Design Response

8466 - Henley Road, Caversham

Document no:	8466-BOW-ZZ-ZZ-RP-A-0010-P0
Revision:	X
Issued for:	Planning
Issue date:	27.10.2022
Reviewed by:	AM

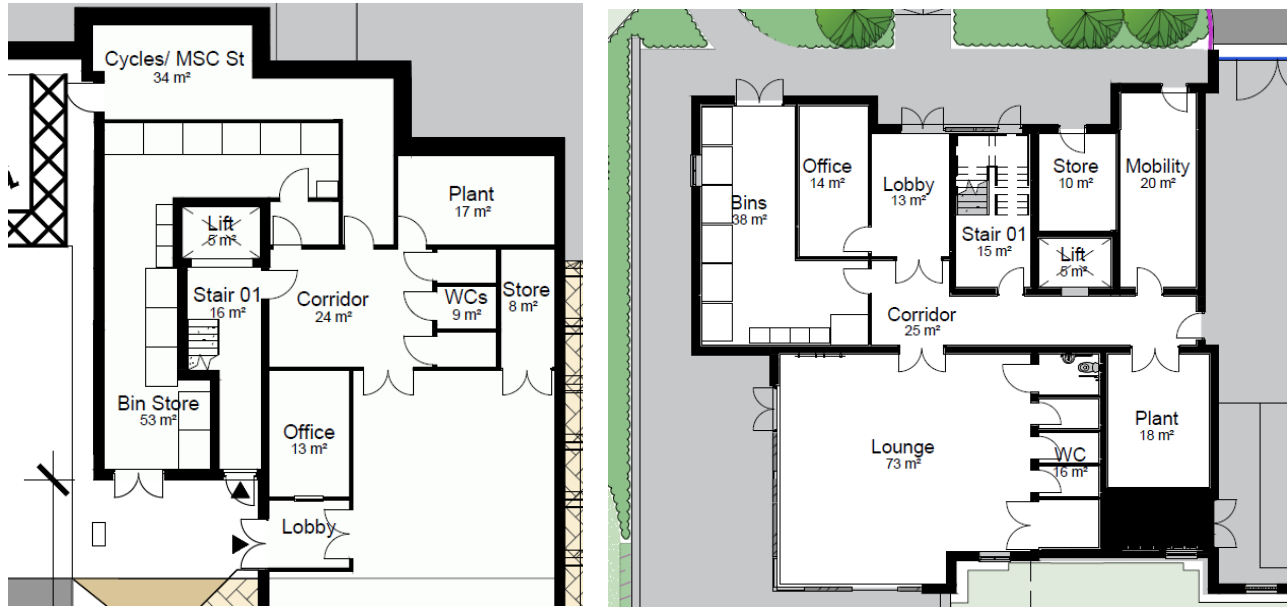
Query: the spaces provided for the storage of waste for both blocks are presently insufficient... Each bin type (with appropriate numbers for each – as below) should individually be shown on revised plans to evidence sufficient provision.

The ground floor areas for both blocks have been redesigned to allow for larger bin stores. The required bin numbers have also been indicated on the plans as per the below, block A (left) and block b (right).

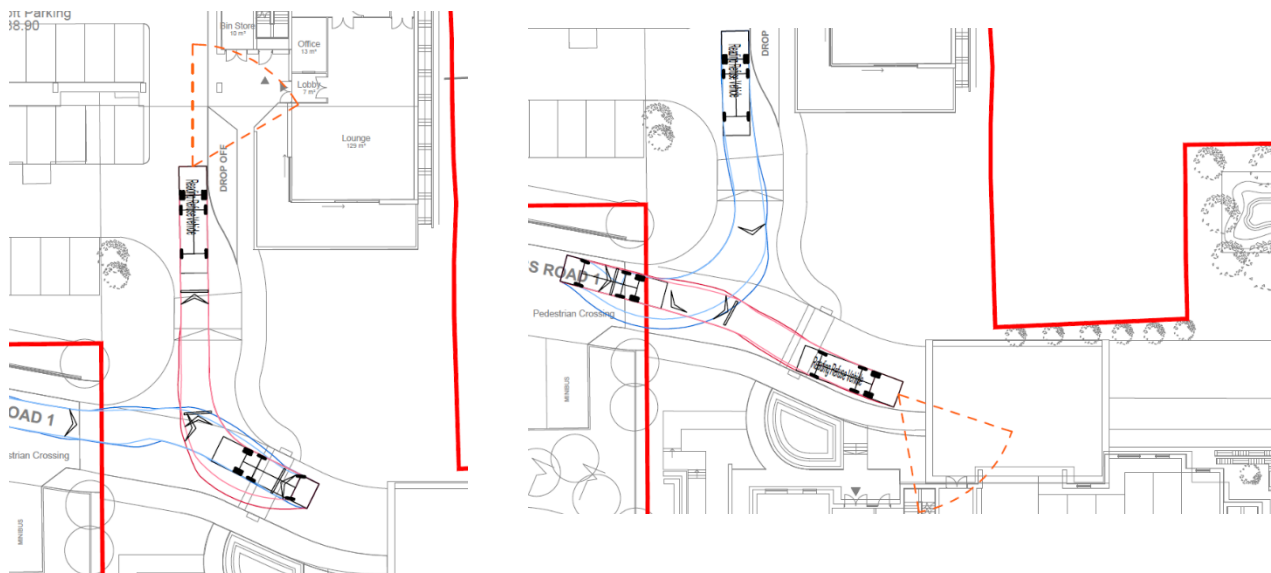
Furthermore, clarity is required in respect of the distance for collection (& if this is over 10m your proposed strategy to address this) and the accessibility of Block A for the refuse vehicles.

Concern is also raised in relation to the turning circle into Block A, and how the RBC collection vehicle would be able to reverse up. It is requested for tracking diagrams be provided to evidence this?

The entrance to Block A bin store has been relocated to the front of the block to reduce travel distances. Please see below extracts of the tracking drawing as prepared and issued by Mode, Block A servicing to the left, Block B to the right.

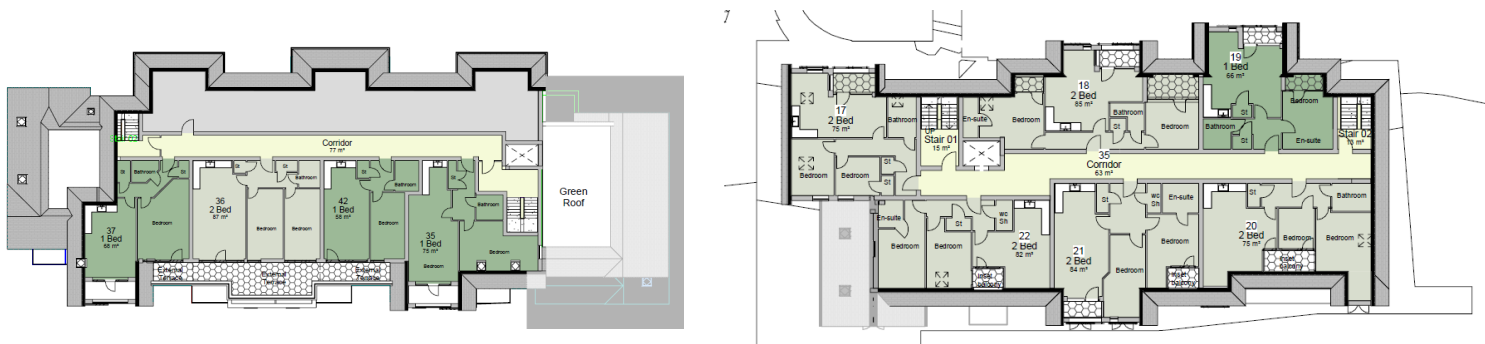
Query: ...a series of habitable rooms would appear to be likely to be served solely by rooflights, therefore resulting in a complete lack of natural outlook for future occupiers (it would also be unclear, until the section plans referenced separately below are provided, what the floor to ceiling heights are at these points too?) It is advised that habitable rooms without any standard windows, or put another way only served by a rooflight, would be extremely unlikely to be considered to provide a suitable quality of accommodation for future occupiers.

The upper floor areas for both blocks have been redesigned to make sure all habitable rooms have a window offering a view out of the spaces as per the below, block A (below left) and block B (below right).
